Work Order ID 152632

Item ID: D2731-3RG Accept *N900040100* Setup Start *NS1*
 Revision ID: Stop *NS2*
 Item Name: Mounting Lug
 Start Date: 11/1/2016 Start Qty: 10.00 *10* Cust Item ID:
 Required Date: 11/2/2016 Req'd Qty: 10.00 *10* Customer:
 Reference:

DRAWING NO. **D2731** REV. C
SHEET 1 OF 5
TITLE **MOUNTING LUG** SCALE NTS

DRAWING NO. D2731	TITLE MOUNTING LUG	REV. C	DART AEROSPACE USA, INC ENGINEERING ORDER		D.E.O. NO. D2731-C-1	SHEET NO. SHEET 1 OF 1	SCALE NTS
DRAWN <i>qp</i>	CHECKED <i>Sc</i>	MFG. APPR. <i>MA</i>	APPROVED <i>MA</i>		DE APPR. <i>MA</i>		
DATE 11.05.02	DATE 11.05.09	DATE 11.05.09	DATE 11.05.09		DATE 11.05.09

D2731-1RG MOUNTING LUG (SHOWN)
D2731-3RG/-5RG/-7RG MOUNTING LUGS (SIMILAR)

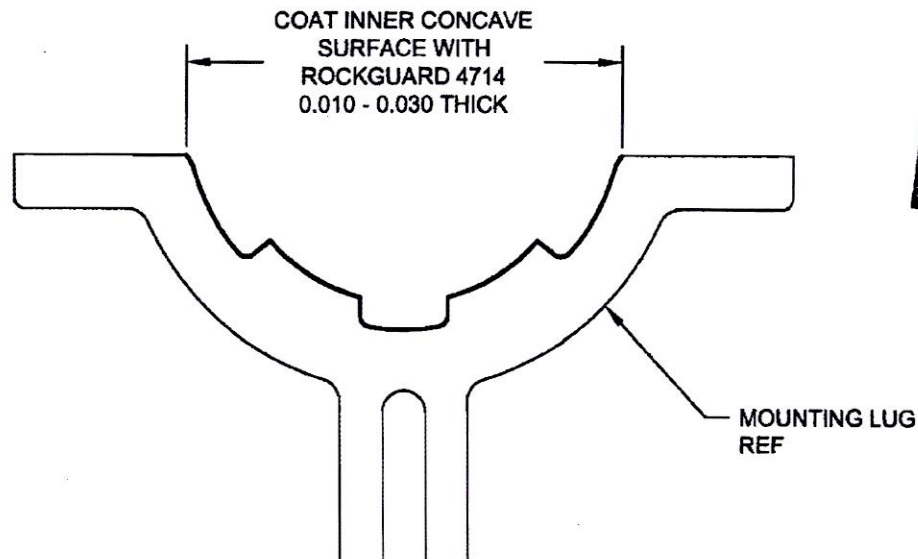
ADD D2731-xRG OPTION

D2731-xRG MOUNTING LUGS ARE INDENTICAL TO D2731-x MOUNTING LUGS, HOWEVER AFTER FINISH, COAT INNER CONCAVE SURFACE WITH "PLUS ONE ROCKGUARD 4714" AS SHOWN BELOW.
